**AMENDMENT NO.13
TO THE PROFESSIONAL
ARCHITECTURAL AND
ENGINEERING (A/E) SERVICES AGREEMENT
BETWEEN THE CITY OF MIAMI BEACH,
FLORIDA AND
WOLFBERG ALVAREZ AND PARTNERS,
INC.DATED OCTOBER 26, 2022**

**FOR THE PROVISION OF ADDITIONAL PROFESSIONAL
ARCHITECTURAL AND ENGINEERING SERVICES FOR THE FLAMINGO
PARK PROJECT IN A NET CREDIT TO THE CITY IN THE AMOUNT OF
\$158,305**

SCHEDULE "A-13" - SCOPE OF SERVICES
CITY OF MIAMI BEACH
Flamingo Park Master Plan
Amendment No. 13 – June 28, 2023

RE: Flamingo Park
 WA Project No.: 28010.00
Subject: Proposal for Additional Services for Modifications to the Softball Field and Credit for Baseball Field Design Services

DETAILS
SHEET NUMBER
A8.02

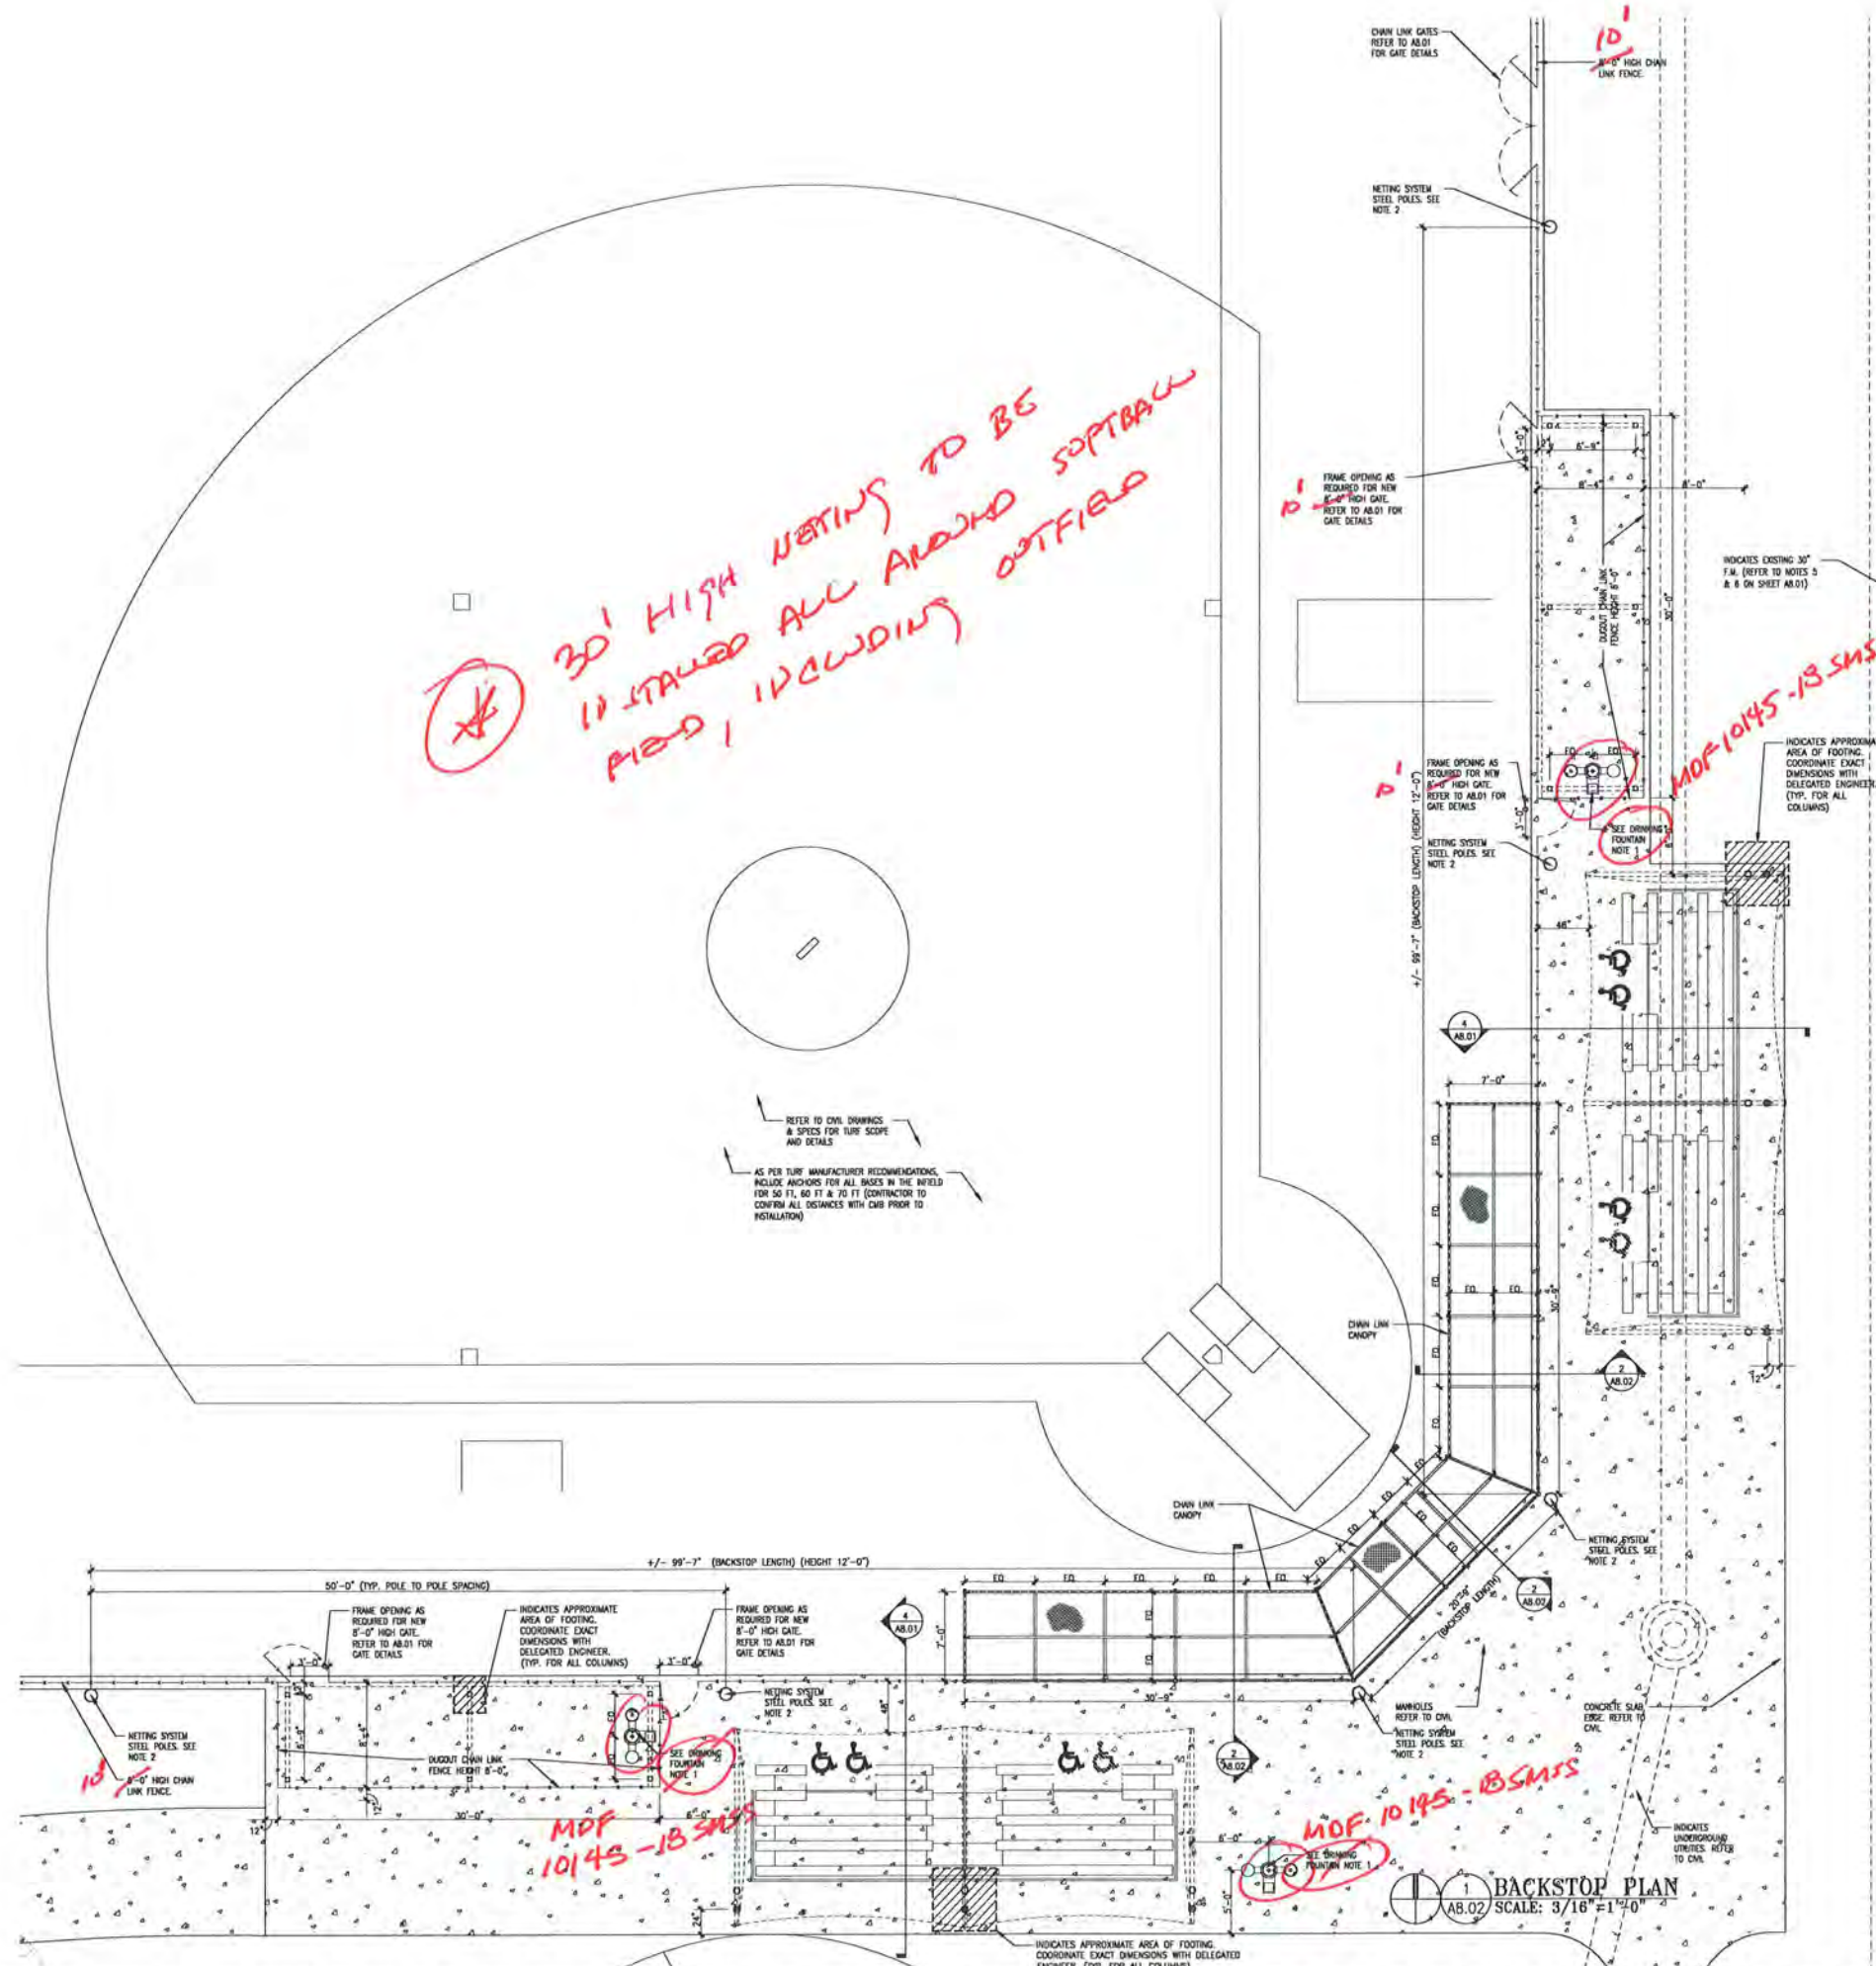
30' HIGH NETTING TO BE INSTALLED ALL AROUND SOFTBALL FIELD, INCLUDING OUTFIELD

20 FEET

13. Backstop canopy height (fencing) to be 20 feet high. Current scope shows backstop canopy height to be 18ft.
14. 30-foot-high sports netting to be installed all around softball field.

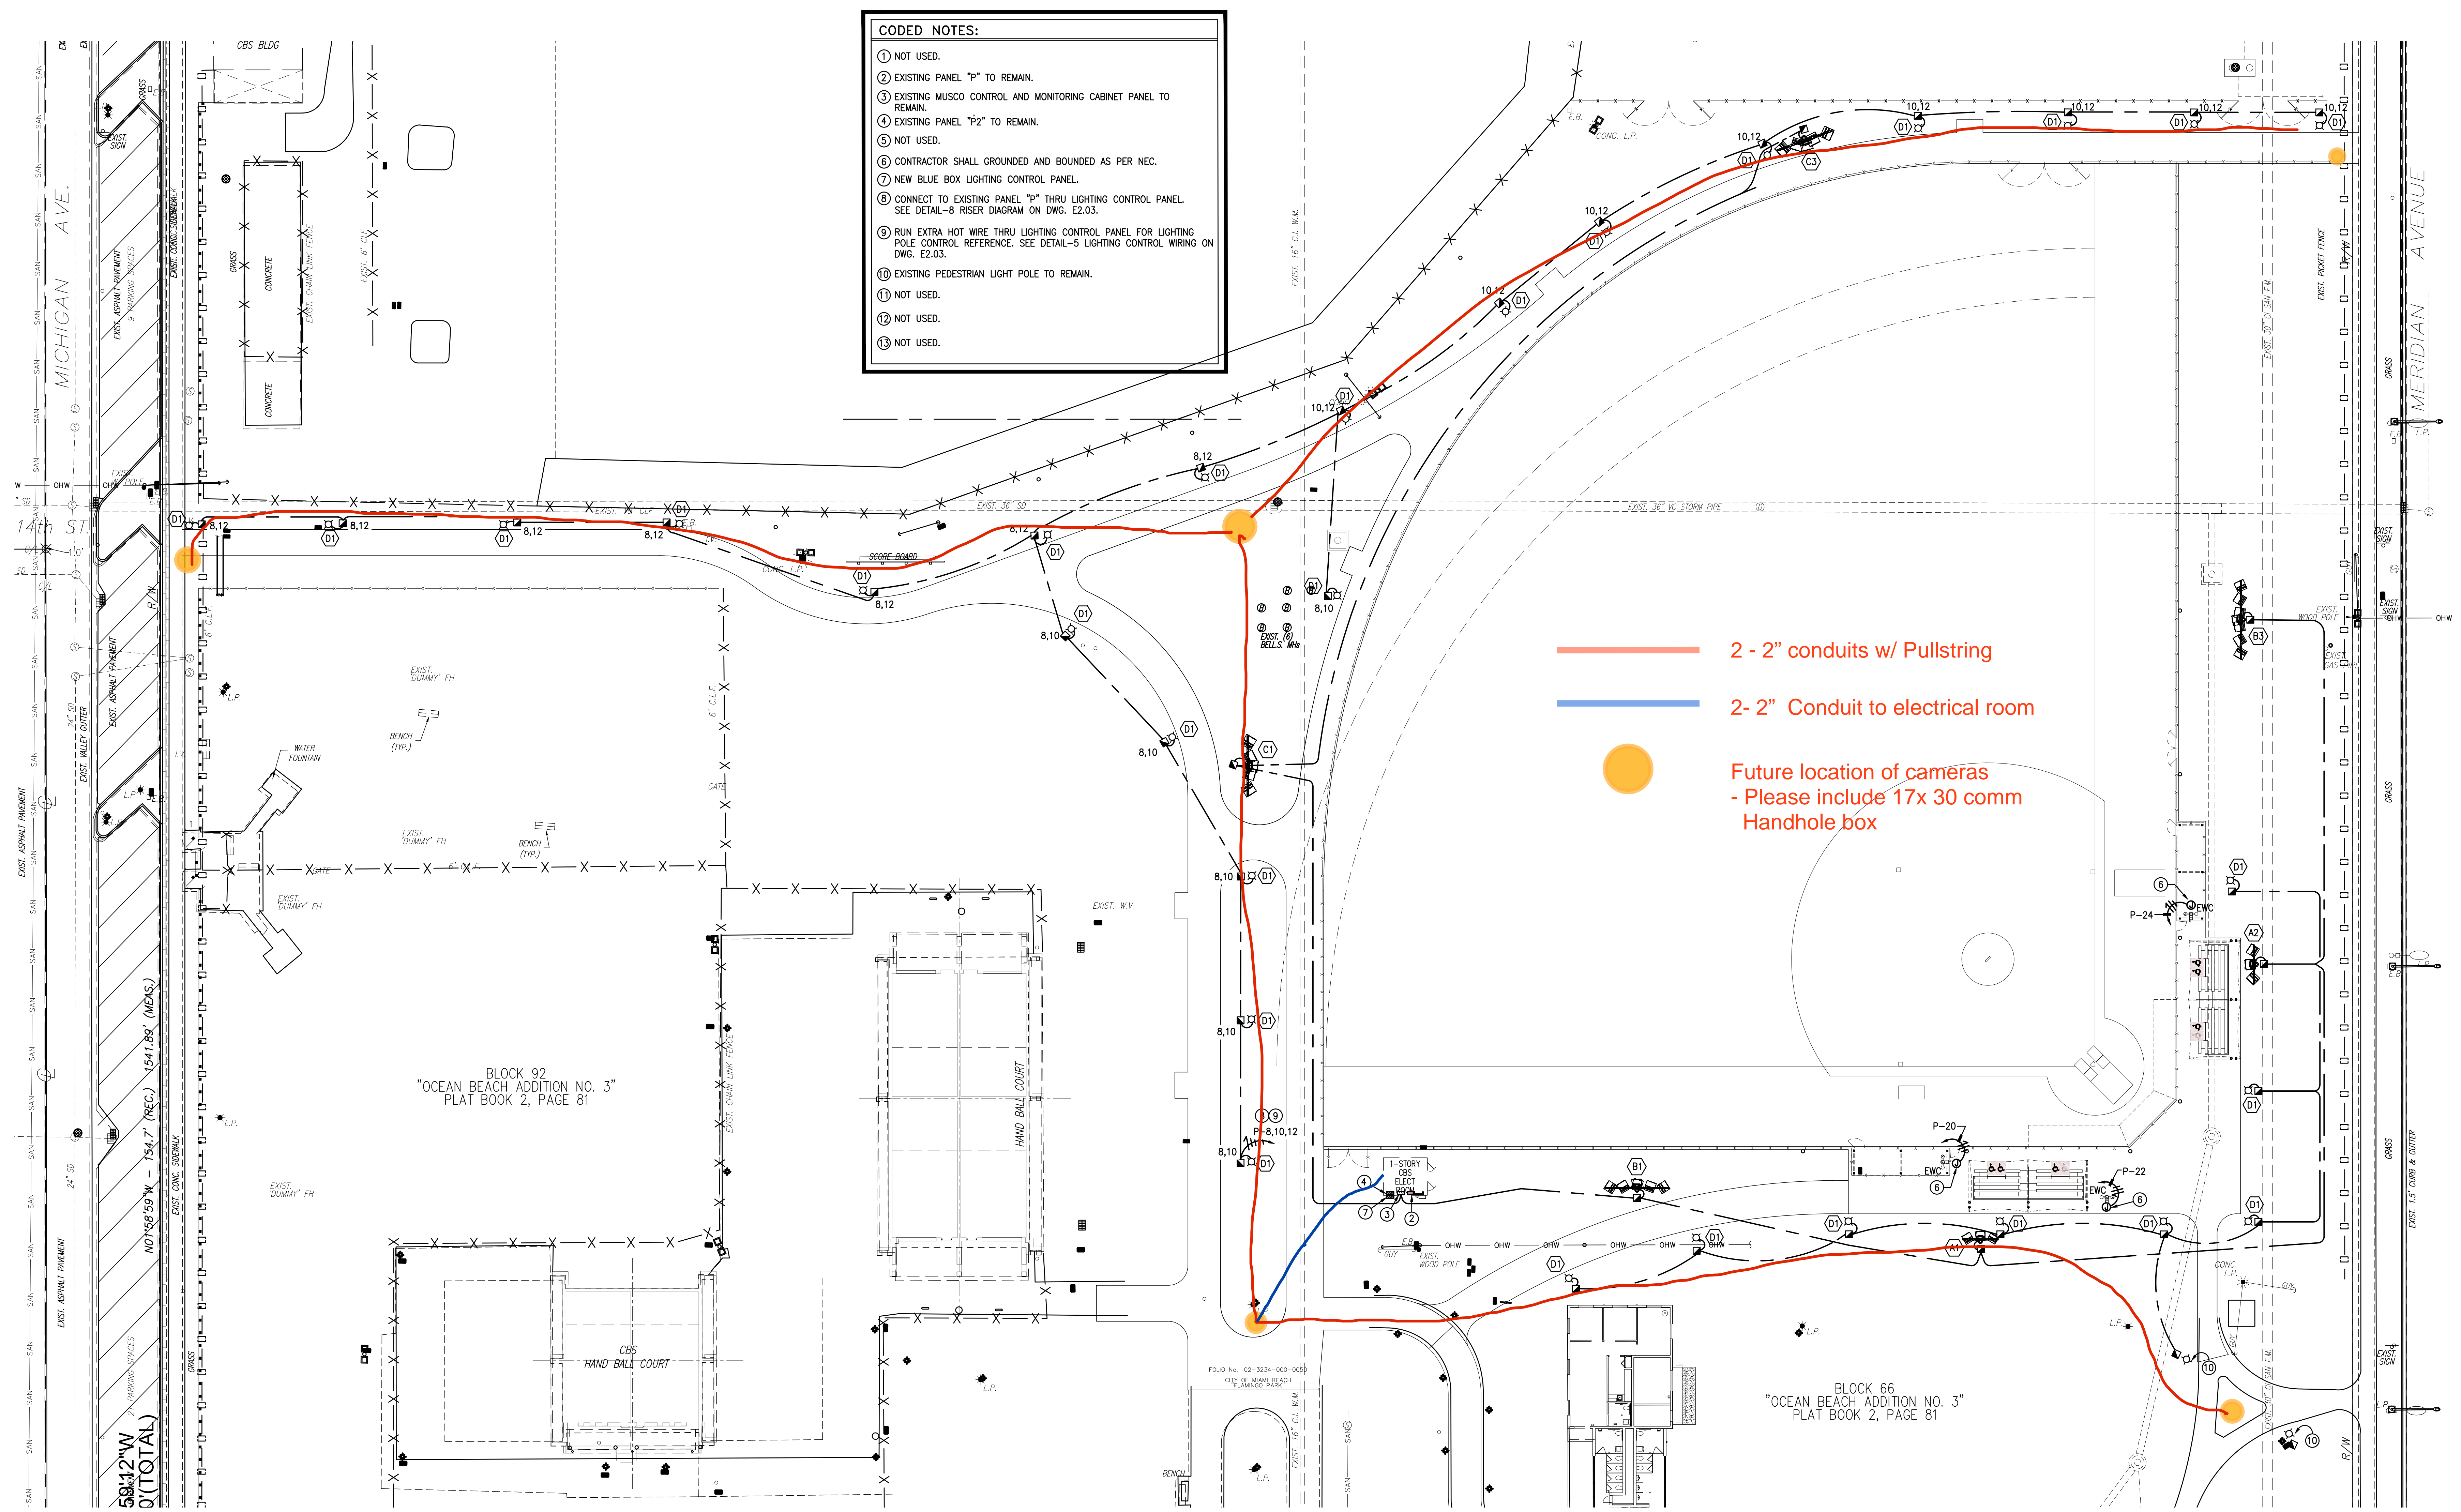
Infrastructure for Police Cameras

17. Include empty conduit with pull strings for future CCTV cameras per mark-up prepared by Police.

SHEET NUMBER
G1.01

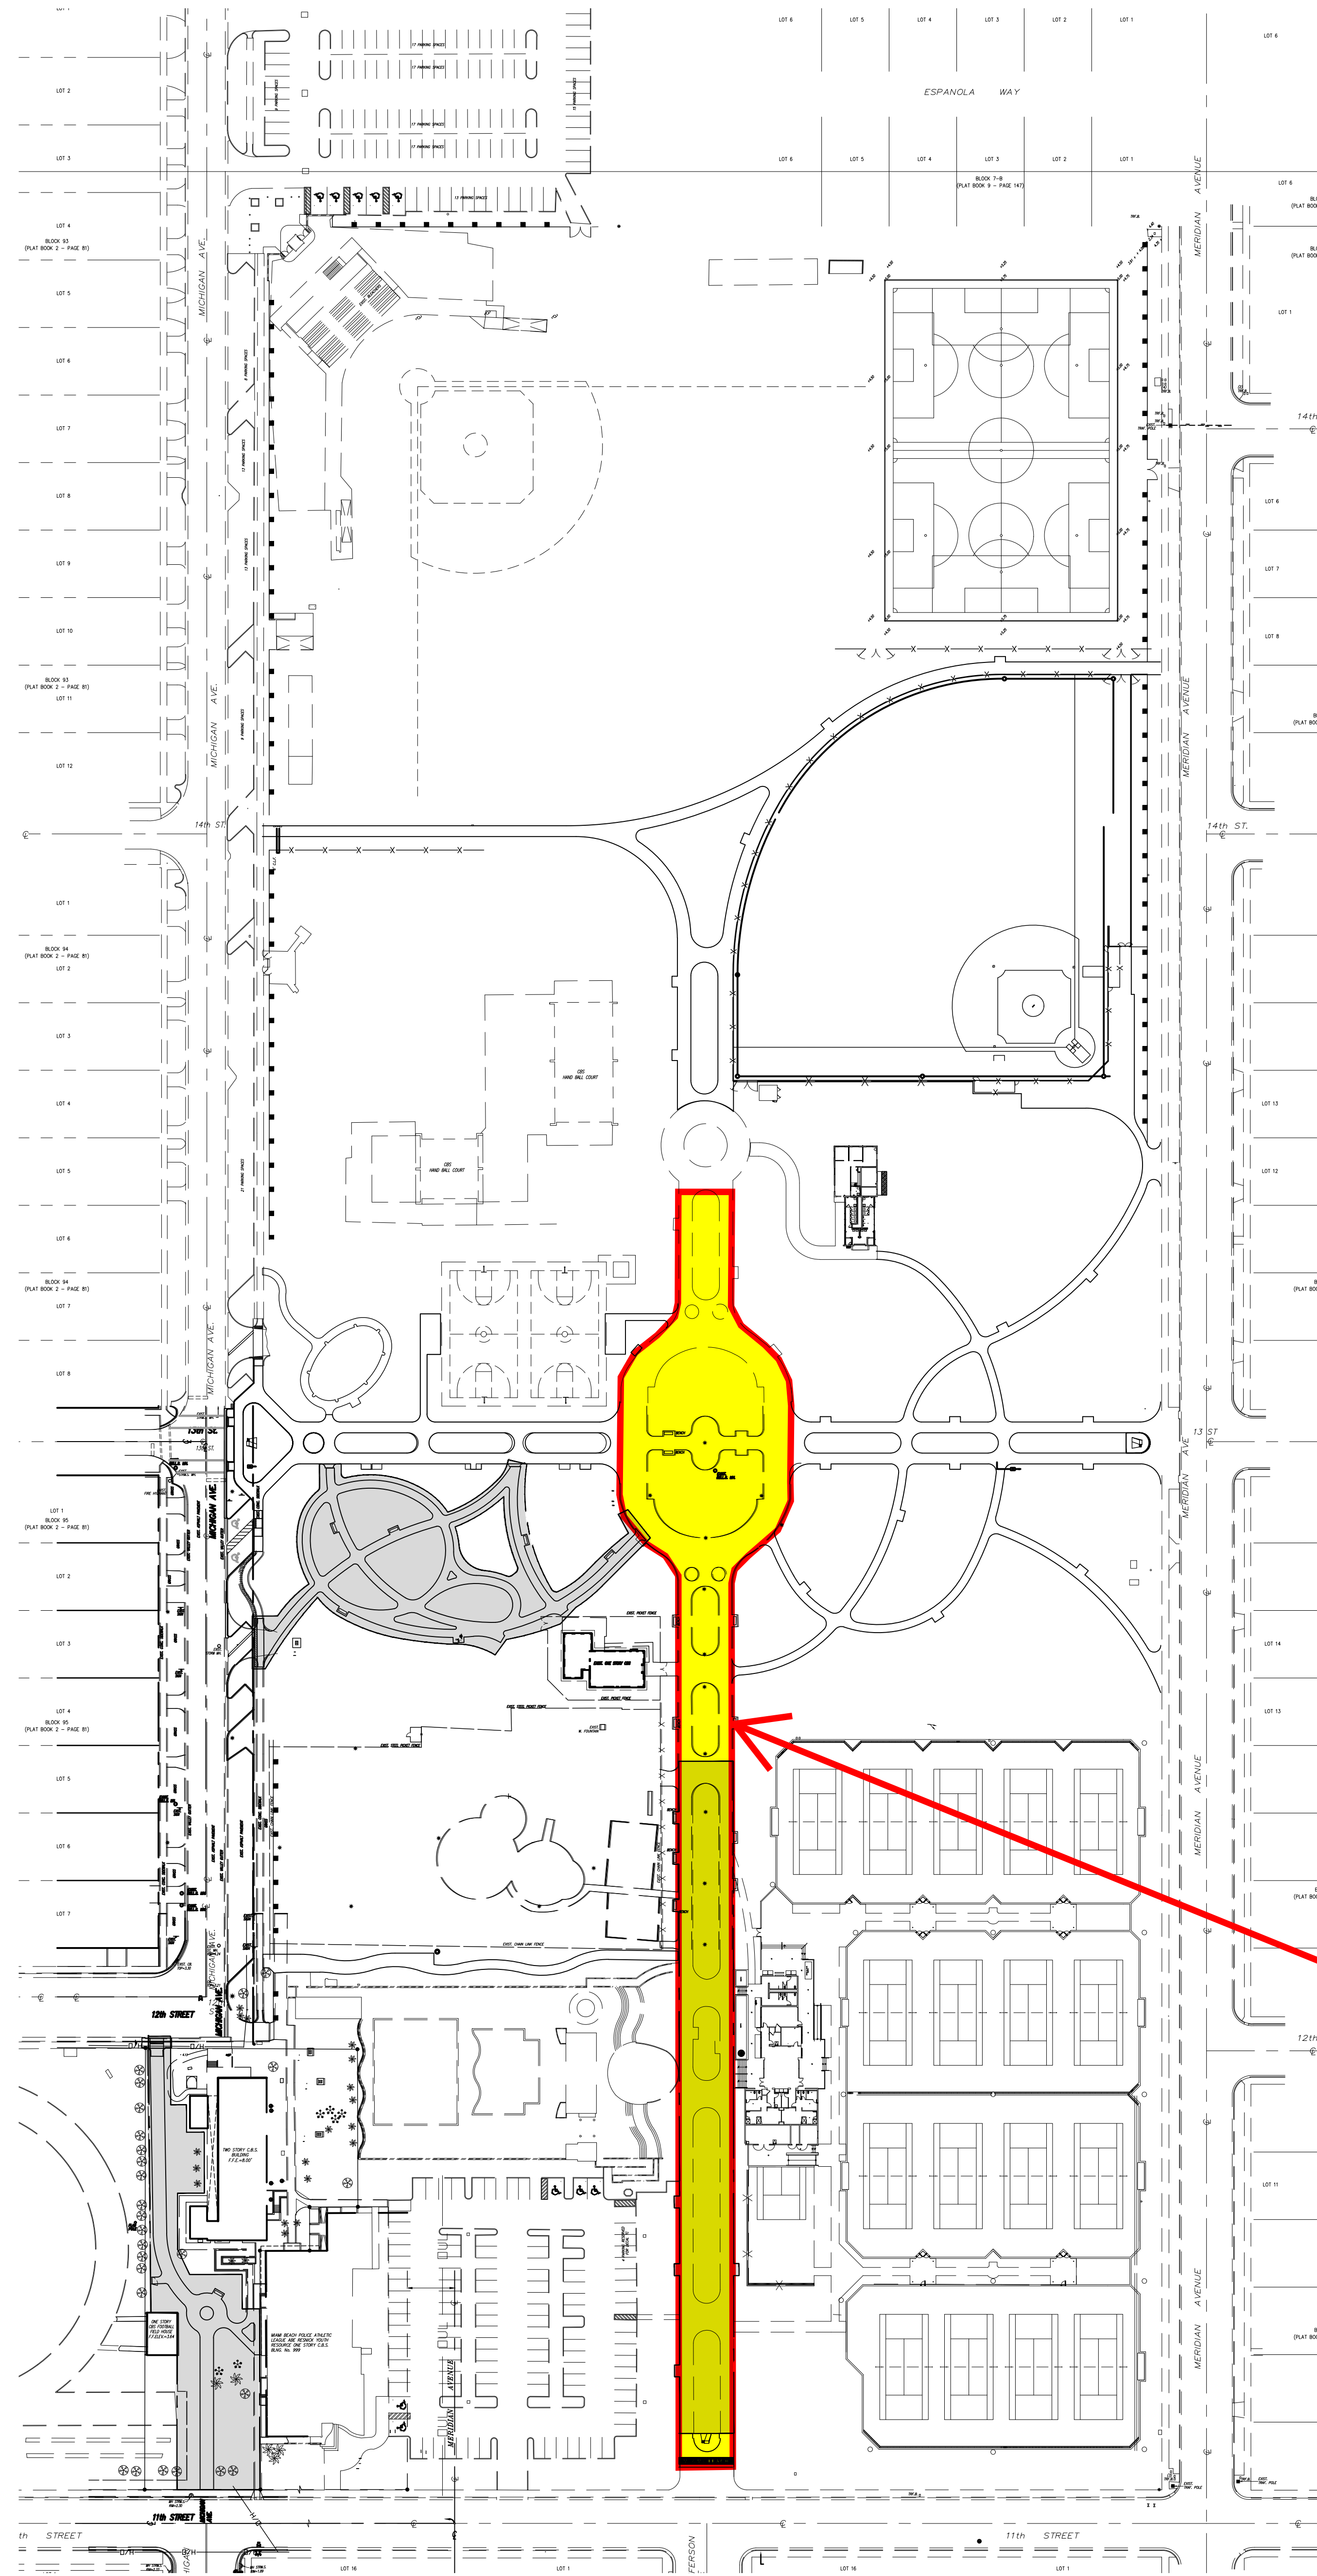
Replace existing lighting poles and reconnect to existing branch circuit. Refer to area highlighted in yellow

18. Resubmit 60% drawings to City for review and comments.
19. Replace existing pedestrian light poles along central plaza, including new power, grounding, control, etc. See attached marked-up G-1.01.
